Iowa Department of Transportation STANDARD ROAD PLAN	REVISION	
	8	10-19-10
	RF-40	
SHEET 1 of 1

**ROCK FLUME FOR
BRIDGE END DRAIN**

PLAN

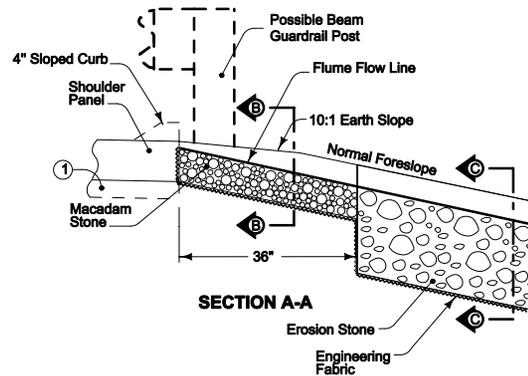
REVISIONS: Corrected labeling errors in prior plan view: Changed Wood Excelsior Mat to Erosion Stone and Scurstop to Macadam Stone in Plan view.
